20 January 2011

Response to Submissions - Section 75W to Major Project: MP 08_0098 Star City Project Star, Multi-Use Entertainment Facility

Figure 1 – Pirrama Road (East) Elevation indicating the revised profile of the MUEF

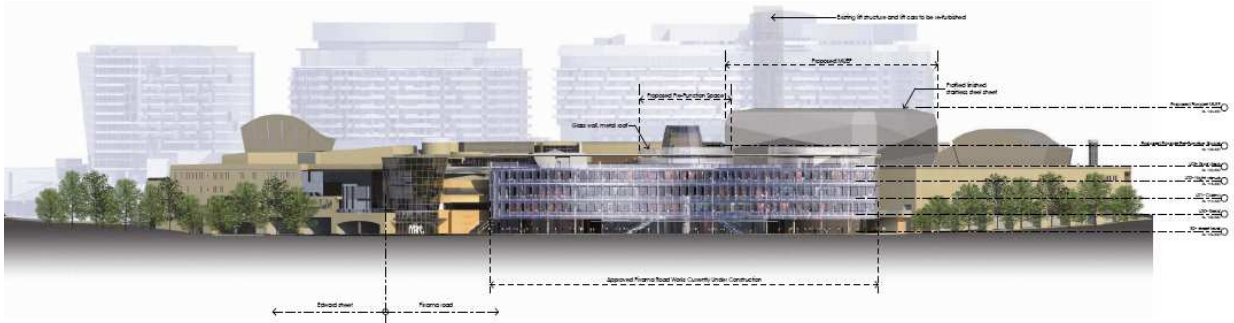
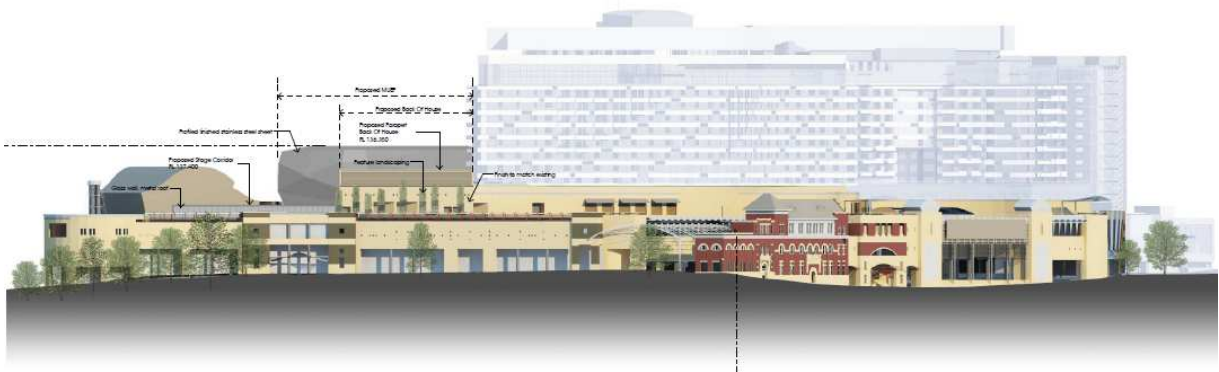
The previously submitted scheme entailed a façade to the MUEF which incorporated external cladding in an opaque material of metallic appearance with a vertical decorative finish. The building outline of the proposed scheme as submitted was rectangular with rounded corners.

The revised scheme amends the external cladding treatment to the MUEF by incorporating a "gem" like shape adopting an external façade of large faceted planes to form a minor convex profile to the MUEF's "external skin", to create a similar appearance of a gemstone (Refer to Figures 1 and 2 below).

As part of this revised profile, the upper corners of the MUEF will become chamfered in form. The façade will constitute finished stainless steel planes which will have a matt satin finish and a reflectivity of less than 20%. Each large faceted plane will be separated with a gap incorporating a strip of lighting element to highlight the edges of the individual facets. The revised façade treatment is proposed in response to the City of Sydney issues raised in relation to visual impact. The amendment visually softens the previous hard lines of the proposed structure.

Figure 5 – Revised Height Control Diagram, based upon the levels at all points of the site

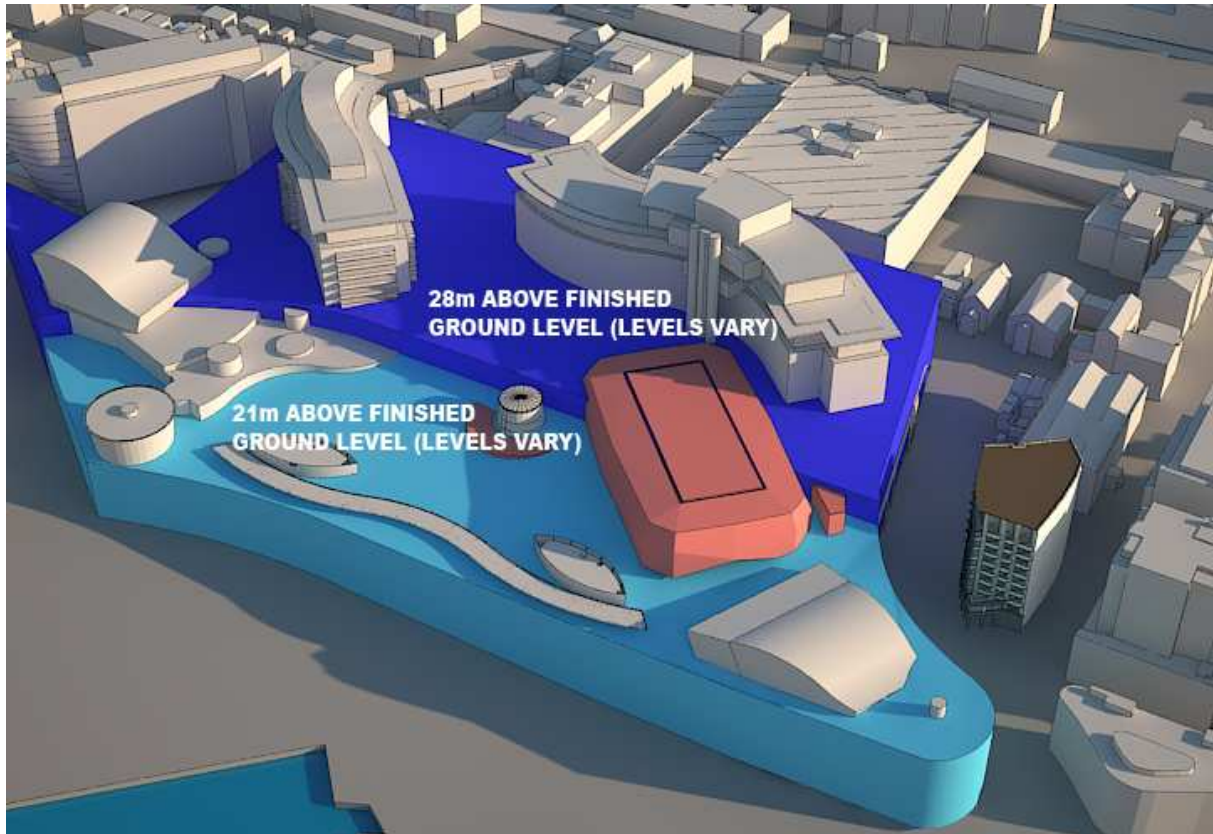
The CoS has queried the methodology adopted in determining ground level for the purpose of calculating compliance with the height standard. The CoS state that the calculation of height should also take into account the ground level at Pirrama Road (RL 102.8) as well as ground level at Jones Bay Road (RL 110.02).

As the entire site has been excavated and the proposed structure has a complex relationship to several irregular frontages, Arterra have been engaged to use survey data of ground levels at all points around the entire site to digitally create an inferred original ground surface for all points on the entire site. This irregular inferred level (3 dimensional surface mesh) was then extruded 21 or 28 metres up as relevant to the applicable height standard (refer Figure 5 below, and Appendix G). This is the only meaningful way of relating the various frontage heights of the site to the proposed structure.

Figure 6 – Amended Internal cross-section of proposed MUEF prepared by Sceno Plus – see A3 copy at Attachment E

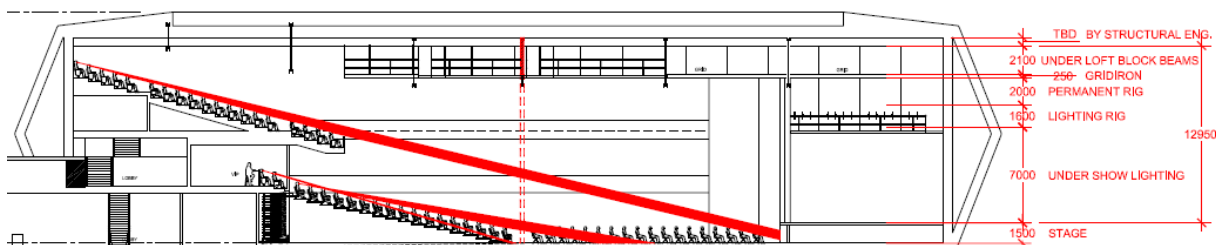
- The methodology adopted in determining proposed height of the MUEF regarding the reliance on a low ceiling.
- The ambiguity of the adopted ceiling level of 5m below the roof; and
- Clarification as to the purpose of an excessive space in between roof and ceiling and therefore whether ceiling height should be actually be higher, such that the calculated height is actually greater than described.

Given the irregular form and variable function modes of the proposed building, it is difficult to define one specific ceiling height. While we note that most buildings have significant roof structure, parapets and roof plant (e.g. lift overruns and chillers) above the height of their topmost ceiling, we have taken the very conservative approach of analysing the visual impact of the topmost structure of the building relative to a height control applicable to the topmost ceiling. Whilst our previous submission identified what we considered to be the ceiling height of the structure, all of our analysis was and is based upon the actual impacts of the topmost points of the structure, which houses all the plant typically provided above roof level.

Regardless of what level one defines the ceiling of the structure be, this level is clearly well below the topmost point of the roof structure upon which our merit assessment of visual impact and view loss has been based.

Figure 9 – Cross Section of Views from No. 2 Jones Bay Road over Proposed MUEF, prepared by Fitzpatrick + Partners - see A3 copy at Appendix H

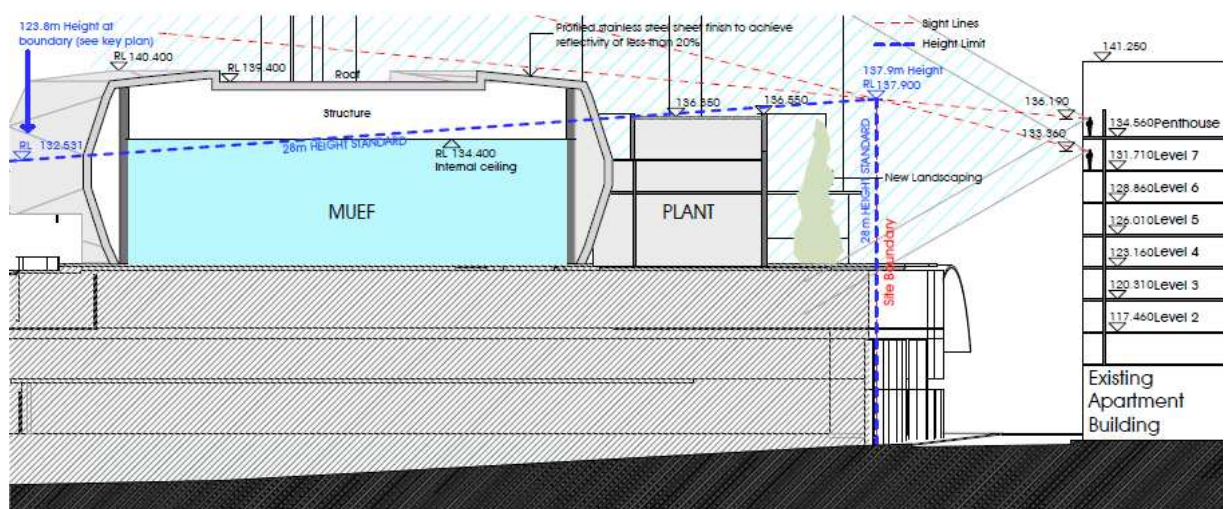
The CoS and Residents of No. 2 Jones Bay Road have raised adverse private view loss impacts as a result of the MUEF. The CoS identify loss of views from floors 3 to 8 facing south east at 2 Jones Bay Road, with significant impact from the 5th floor and above. CoS recommends utilising the Land and

The revised external form of the MUEF façade results in chamfering to the upper roof perimeter of the MUEF which will lower the perimeter height as viewed from the upper levels of the adjacent apartment building at 2 Jones Bay Road. This design enables an improvement of views towards the south-east in comparison with the previously submitted scheme in October 2010. Revised photomontages and a revised visual impact assessment have been prepared and illustrate that the impact upon views from the two most affected units on the opposite side of No. 2 Jones Bay Road will be less than that of a compliant scheme. This is discussed in greater detail in the Visual Impact Assessment prepared by GMU Design and attached as Appendix D. The montages upon which this analysis is based are included in A3 form at Appendix F.

- At the eastern balconies of Levels 3 to 6, a hypothetical development complying with the 28 metre height limit would obstruct the full height of views west of the intersection of the 21 and 28 metre height zones. However, most of the existing view over the 21 metre height zone would be retained.

- When viewed from the eastern balcony at Level 7, as the eye level of a person standing on the balcony is lower than the height of a 28m vertical plane above the Jones Bay Road frontage of the site, sightlines over the 28 metre vertical plane will continue on an inclined plane such that they project over the MUEF, obscuring views to the MUEF.

- As eye level standing on the eastern balcony of Level 8 is still lower than the height of a 28m vertical plane above the Jones Bay Road frontage of the site, a hypothetical compliant development would still screen views from the Level 8 Balcony to the MUEF.
